Lattin's Cove State Boat Launch Improvements

Danbury, Connecticut

Environmental Review Team Report

for the
Danbury Mayor's Office

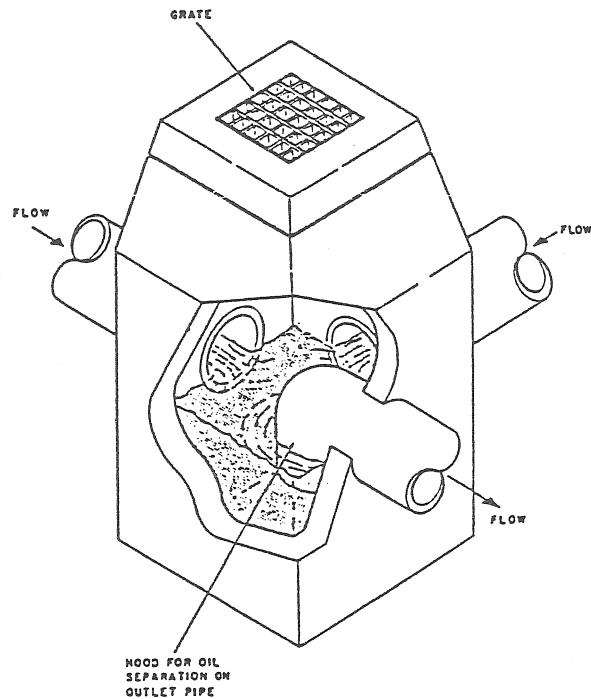
A standard catch basin is illustrated here, modified with a hood on the outlet pipe. This provided oil separation. The catch basin sump serves to retain trash and sediments and must be cleaned periodically if it is to function as intended.
